RE: Way Dam Hydroelectric Project, FERC No. 1759-036
Article 418-Low Dissolved Oxygen Mitigation- 2005 Progress Report

Way Dam Hydroelectric Project, FERC No. 1759-036
Article 418

Low Dissolved Oxygen Mitigation Plan
Draft Progress Report Year 2005

We Energies Consultation With Agencies – Documentation
of Requests and Replies

Figure 1 DO continuous monitoring vs. water use, June-September, 2005

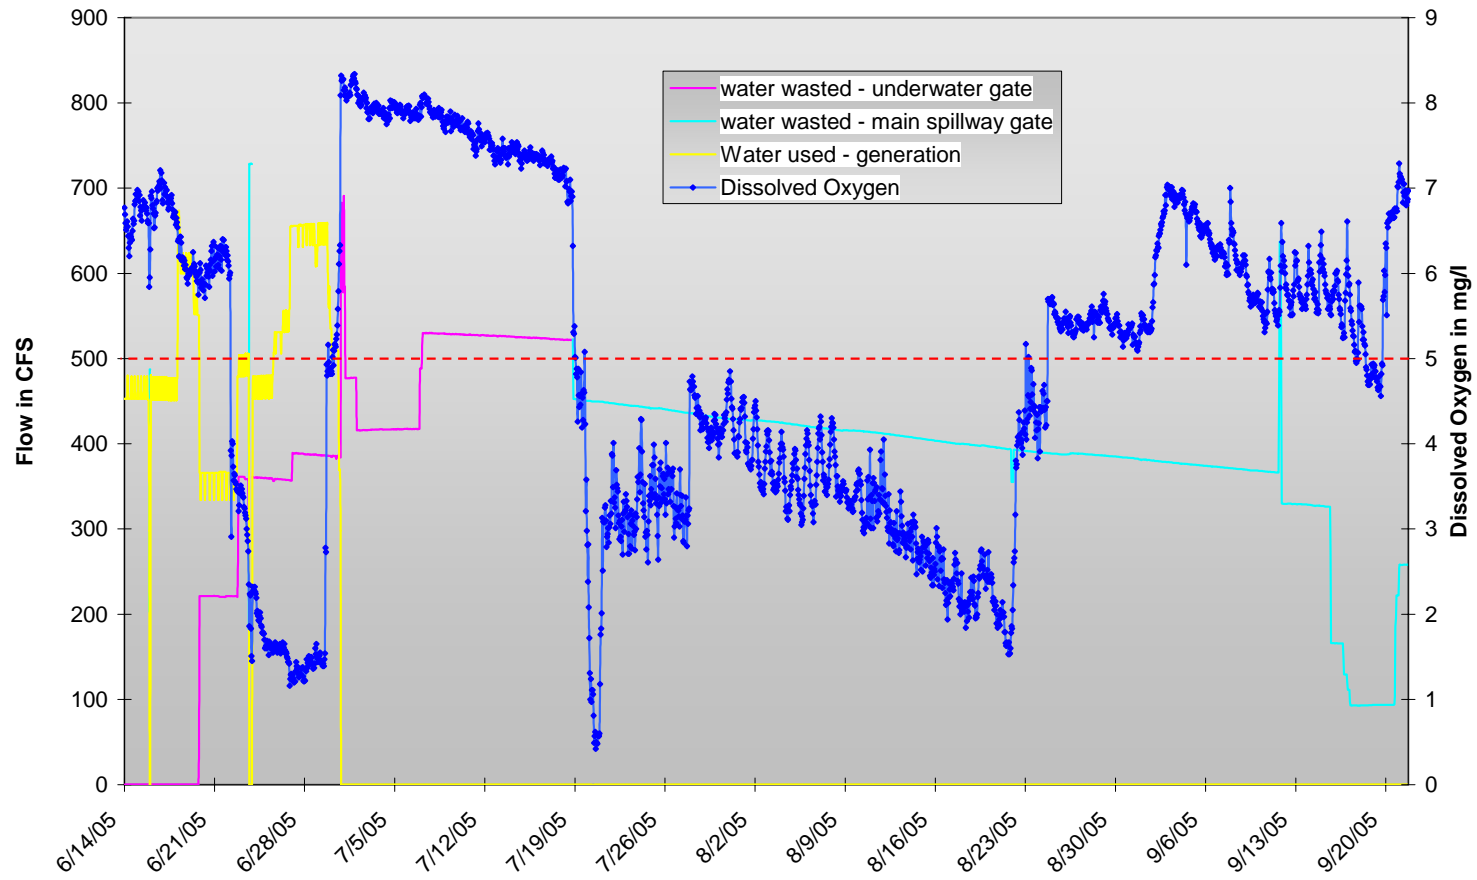
Figure 1 should show the scale for dissolved oxygen as well as flow. You should indicate on Figure 1 which monitoring location the data are from.

Figure 1 should show the scale for dissolved oxygen as well as flow. You should indicate on Figure 1 which monitoring location the data are from.

Figure 1 should show the scale for dissolved oxygen as well as flow. You should indicate on Figure 1 which monitoring location the data are from.

Figure 1 Location of vertical profile measurements (O), continuous recording data sondes (X) during 2005

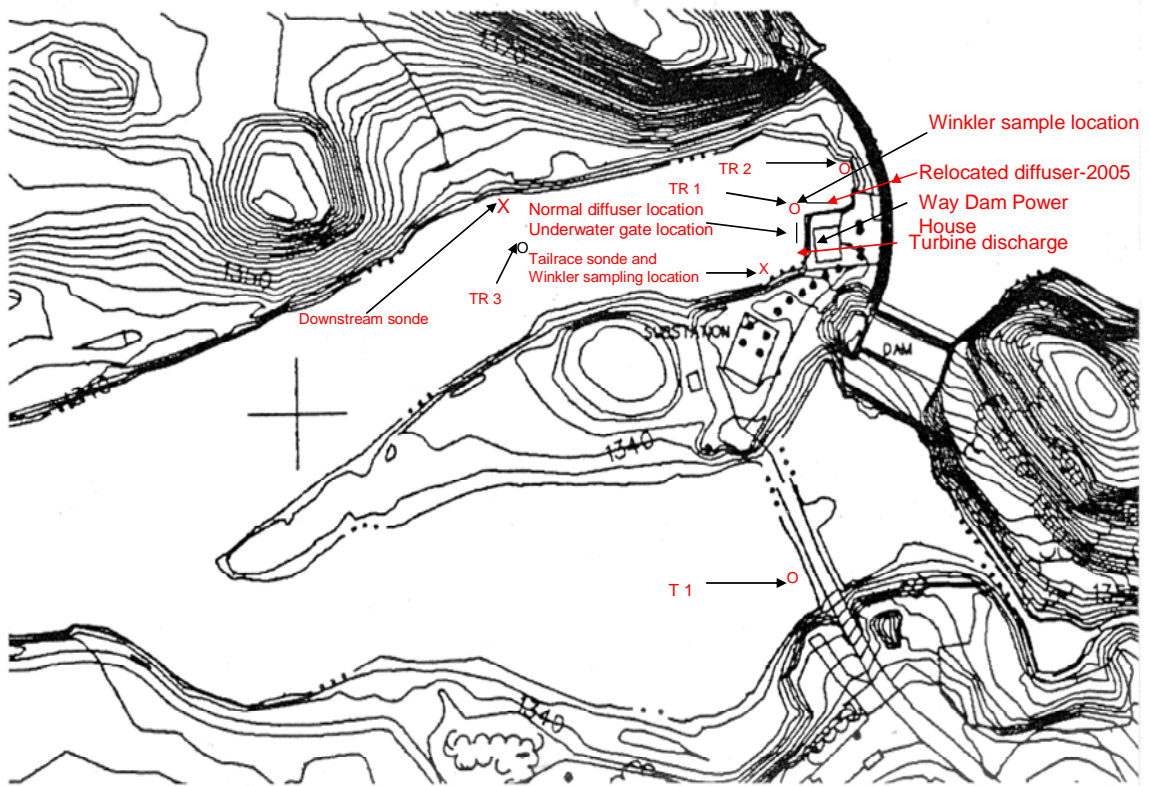
The report should include a plan view drawing of the area immediately around the turbine discharge to show locations of all sampling points, the turbine discharge location, the underwater gate discharge location, the diffuser locations and the sampling locations. I could not tell from the draft report or the supplemental information you sent whether the sampling locations were appropriate or not.

The report should include a plan view drawing of the area immediately around the turbine discharge to show locations of all sampling points, the turbine discharge location, the underwater gate discharge location, the diffuser locations and the sampling locations. I could not tell from the draft report or the supplemental information you sent whether the sampling locations were appropriate or not.

The report should include a plan view drawing of the area immediately around the turbine discharge to show locations of all sampling points, the turbine discharge location, the underwater gate discharge location, the diffuser locations and the sampling locations. I could not tell from the draft report or the supplemental information you sent whether the sampling locations were appropriate or not.
